Zoning Violation

Discrepancies in Warren Creek Extension Shared Infrastructure

November 28, 2016

Courtney and Warren Palmer
Saxon Oaks Co.
122 Skunk Hollow Road
Jericho, VT 05465

SUBDIVISION PLAN
ISABEL BASLOW
FIVE LOT SUBDIVISION

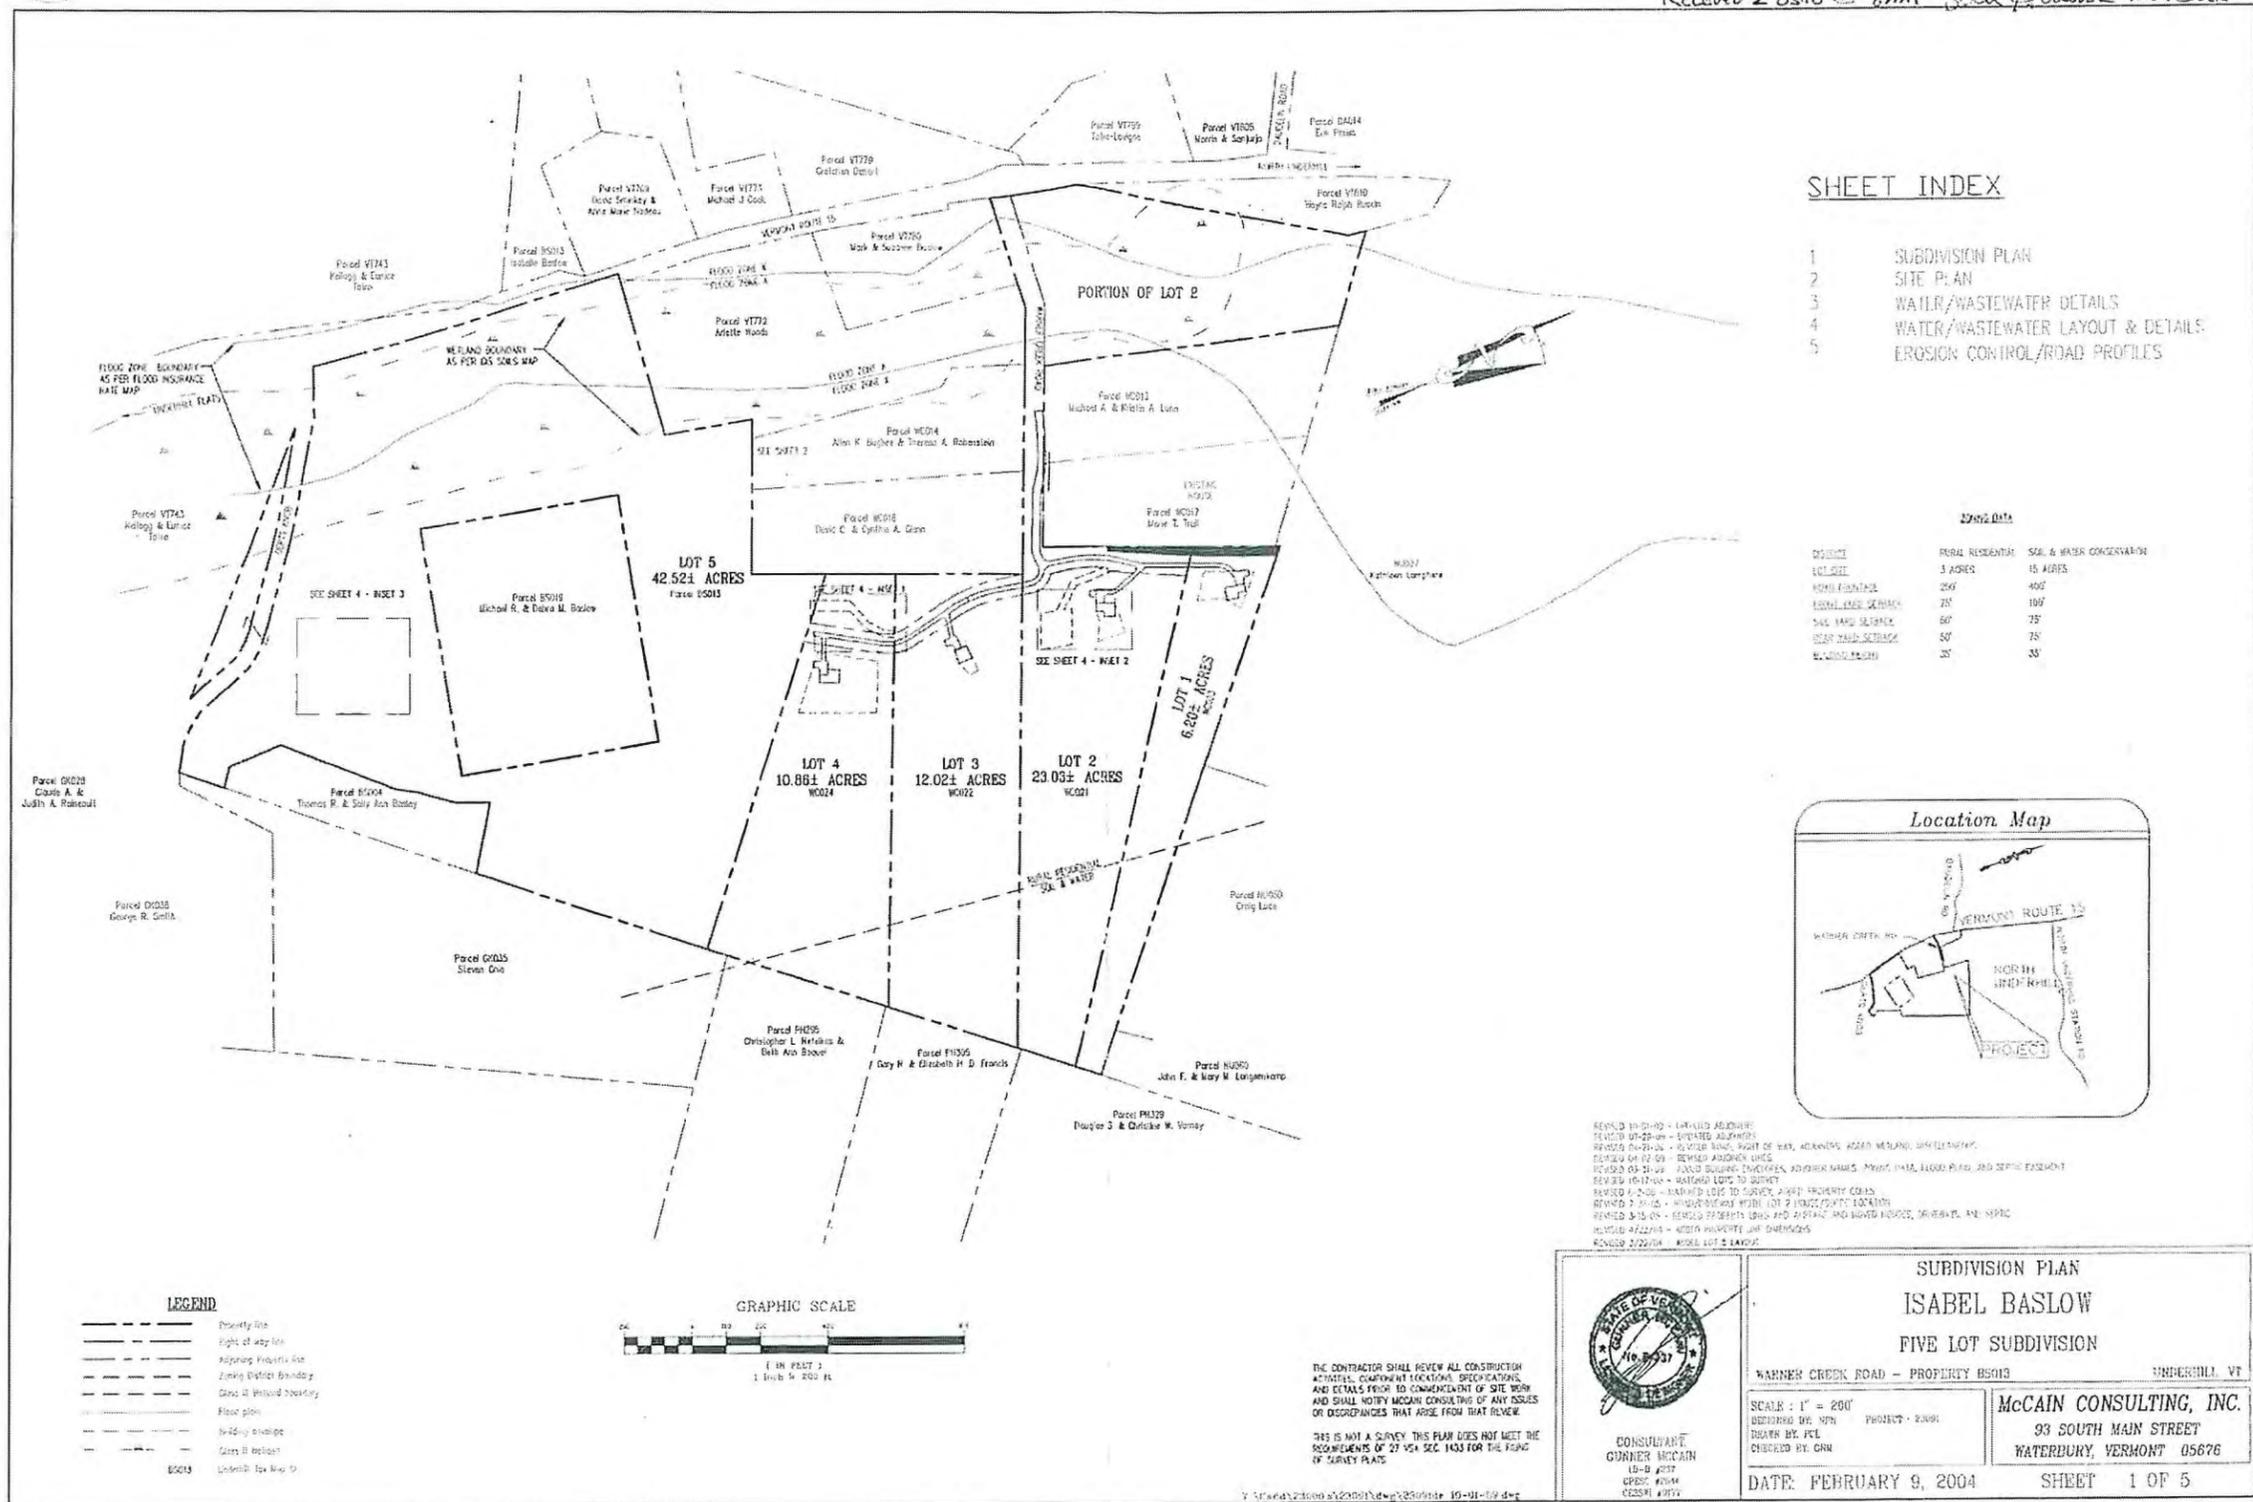
The Site Plan (Attachment D) illustrates that Lot 3 should contain three culverts: two 24-inch culverts to be installed under the Warner Creek Extension road and one 18-inch culvert to be installed under the proposed driveway. No culverts were proposed or approved for Lot 4. As shown in Mr. Holden's survey (Attachment H), two 18-inch culverts, rather than 24-inch culverts, were installed on Lot 3 under the Warner Creed Extension. A 15-inch culvert, rather than an 18-inch culvert, was installed under the proposed driveway on Lot 3. Furthermore, an unapproved 12-inch culvert was installed under the Warner Creek Extension road on Lot 4.

While the road is situated within the right-of-way per Mr. Holden's survey (Attachment H), the roadway clearly deviates from what was shown in the Site Plan (Attachment D). In the Site Plan, the road was oriented to traverse the right-of-way directly in the center; however, the as-built road skews from the center of the right-of-way starting on Lot 3, and continues to be out of place on Lot 4.

The Final Plat (Attachment B) illustrates a septic easement on Lot 4, which is further supported by the Site Plan (Attachment D). The septic easement on Lot 4 should contain the sewer pipe coming from Lot 3 and the leach field for Lot 3. While the leach field for Lot 3 is within the septic easement on Lot 4, the sewer line was found to be misplaced, and not located within the easement (see Attachment H).

1. The as-built septic tank is located on the south side of the house instead of the north side of the house as proposed in the Site Plan (Attachment D and Attachment H);
2. The as-built drilled well on Lot 3 is located in a different site than the design location (Attachment H);
3. The as-built drilled well on Lot 4 is located in a different site than the design location (Attachment H); and
4. The right-of-way on Lot 3 is slightly askew from what was proposed in the Final Plat (Attachment B and Attachment H).

Thus, all of the abovementioned culverts are in violation of the Site Plan, and more specifically, the Lot 3 driveway culvert and the Lot 4 road culvert are also in violation of the 2002 Road Policy. Therefore, the Lot 3 culverts shall be replaced as per the Site Plan, and the Lot 4 culvert shall be removed.

Although the DRB's approval notes that shared infrastructure would be installed **to the lot** (per condition III.4.a of the DRB's decision in Attachment A), upon the development of Lot 4, the infrastructure was required to be built in accordance with the DRB-approved and recorded plans. While it is common practice to delay lot development following subdivision approval, Lot 4 is now developed and must therefore be completed per the approved plans. As a result, a subdivision revision is required to address the orientation of the road.

A subdivision revision application shall be submitted to allow the DRB to review these changes as part of an amended Site Plan. Furthermore, we have referred these issues to ANR.

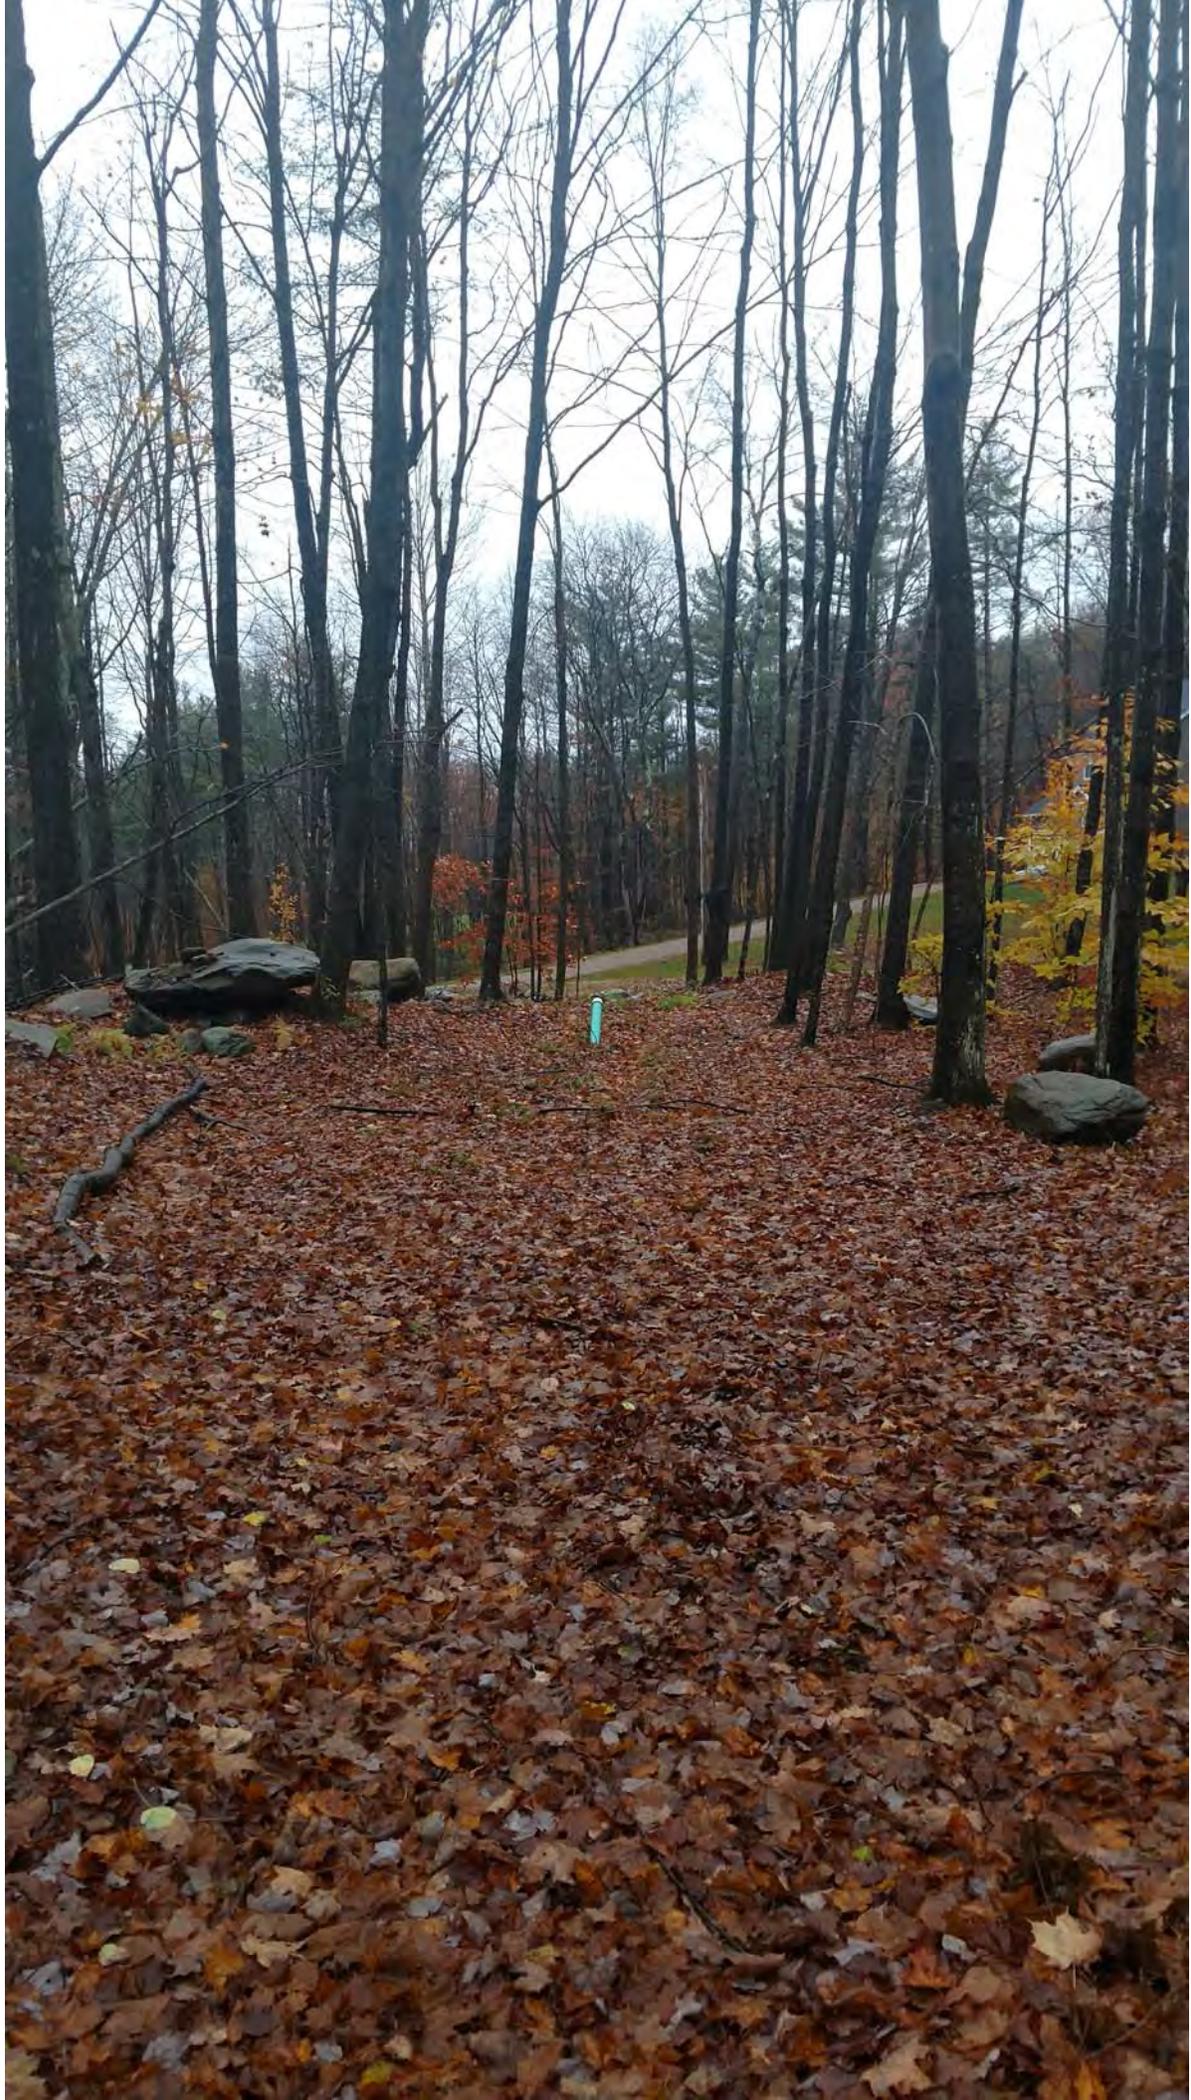
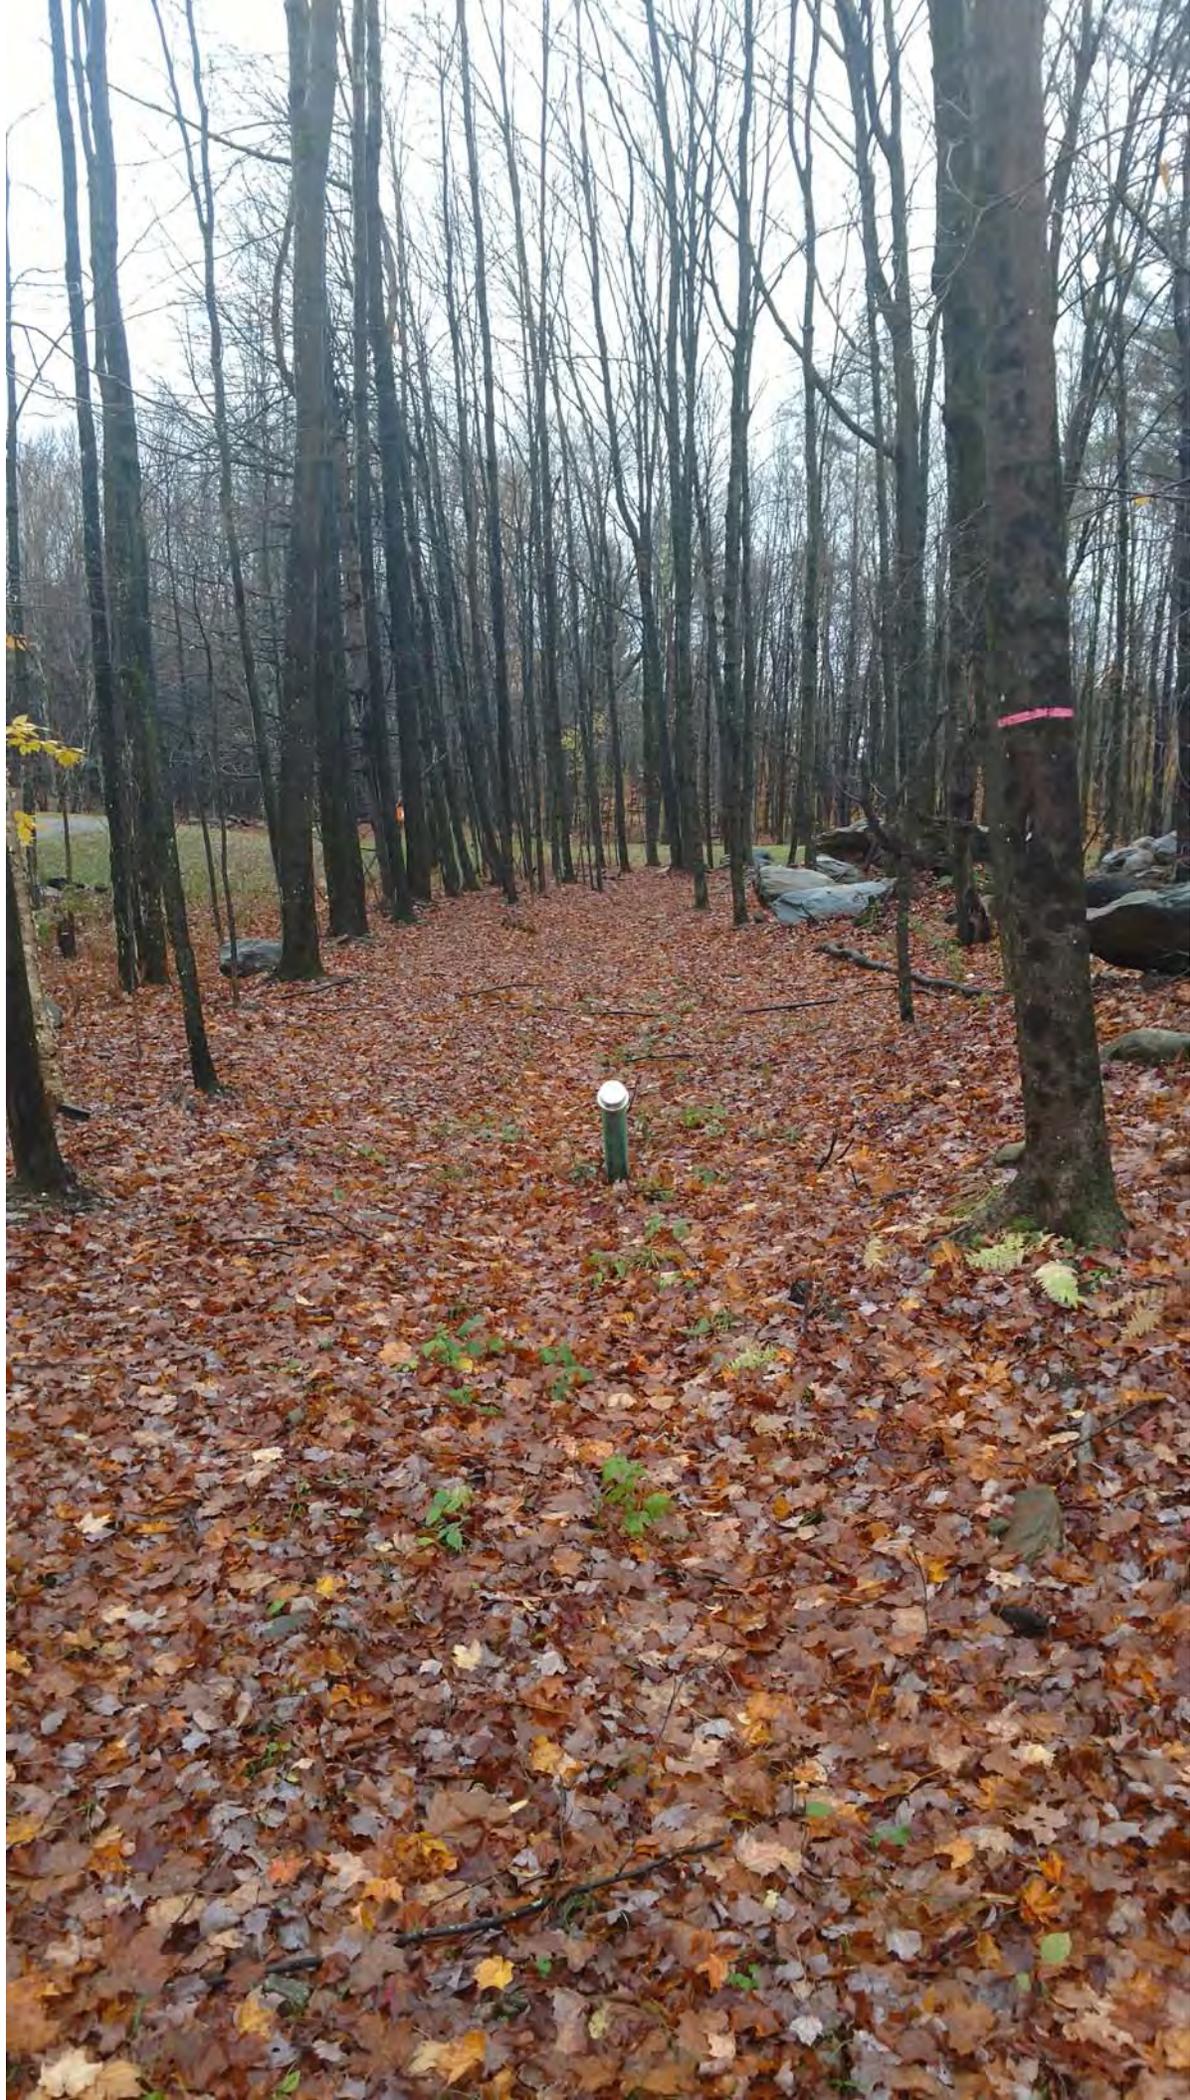
I agree with the location of the disposal fields as depicted on the site plan dated June 27, 2016 prepared by McCain Consulting, Inc. However it appears that the sewer pipe coming from Lot 3 to the disposal field was not constructed within the easement area. I have based this upon the direction of the cleanout, which is near the Lot 3 and 4 boundary, and the direction of the pipe coming into the distribution box as well as the evident path through the woods. See photographs attached. The only sure way to know would be to run a locator beacon down the pipe.

I located the existing well locations, as shown. The design locations were scaled from the McCain drawings. There are irregularities in the McCain drawings, as far as the scale is concerned, so those are shown as approximate only.

These issues all appear to be fairly minor in nature and could be easily resolved by submitting amended drawings to the State, if necessary, and by exchanging deeds between the owners of Lot 3 and Lot 4 to reflect a revised easement location.
